# PRELIMINARY ENVIRONMENTAL ASSESSMENT MEMORANDUM

SUBJECT: Preliminary Environmental Assessment for AC Water Group 1019, Internal Order

No. 21002242

# AC Water Group 1019 – Geotracker Map Listings

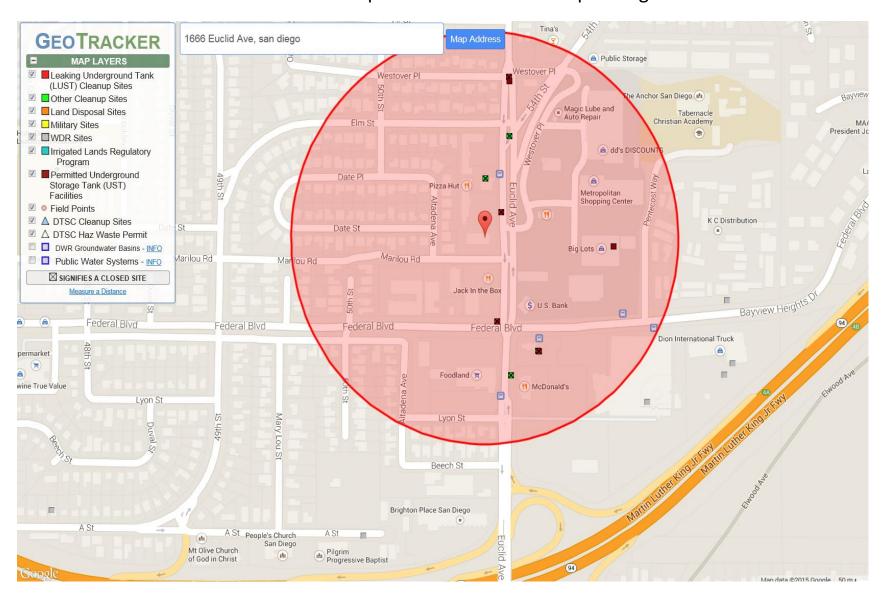
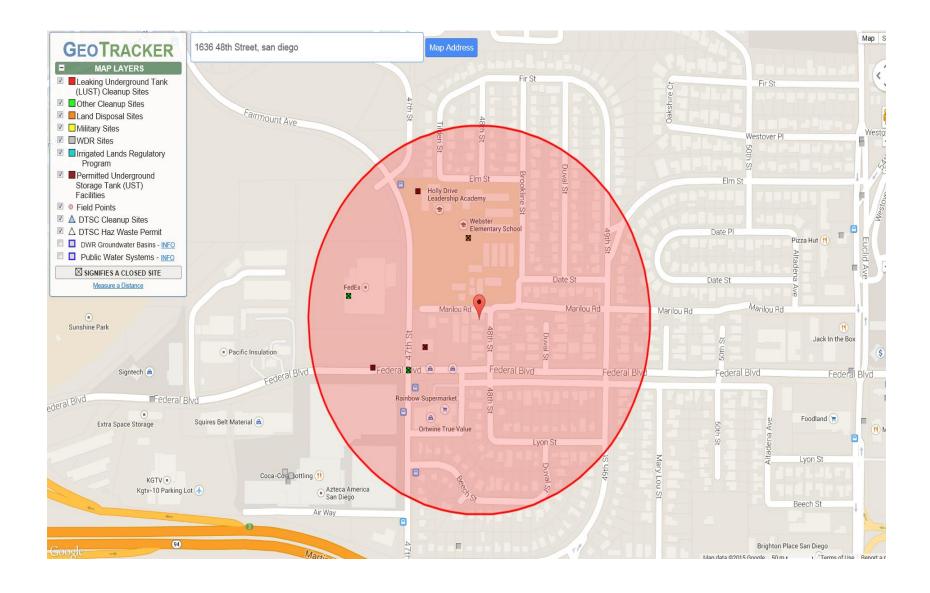
There is one burn site/landfill located adjacent to the project area identified as Webster Elementary. Please see the attached Geotracker Site Listings Map for the exact location.

There are five leaking underground storage tank (LUST) cases documented within 1,000 feet of the project, and four permitted underground storage tanks.

Action: A listing of these cases and the addresses is attached. All cases, including closed ones, have the potential to contain contaminated soil or groundwater and could potentially be harmful to human health and the environment if disturbed. Appropriate references to the potential to encounter contaminated soil or groundwater or other regulated wastes should be included in construction specifications in the case that contaminated materials are encountered. Although not required, any boring or geotechnical reports done prior to construction would be helpful for potential bidders to determine costs associated with dewatering and/or contaminated soil/groundwater.
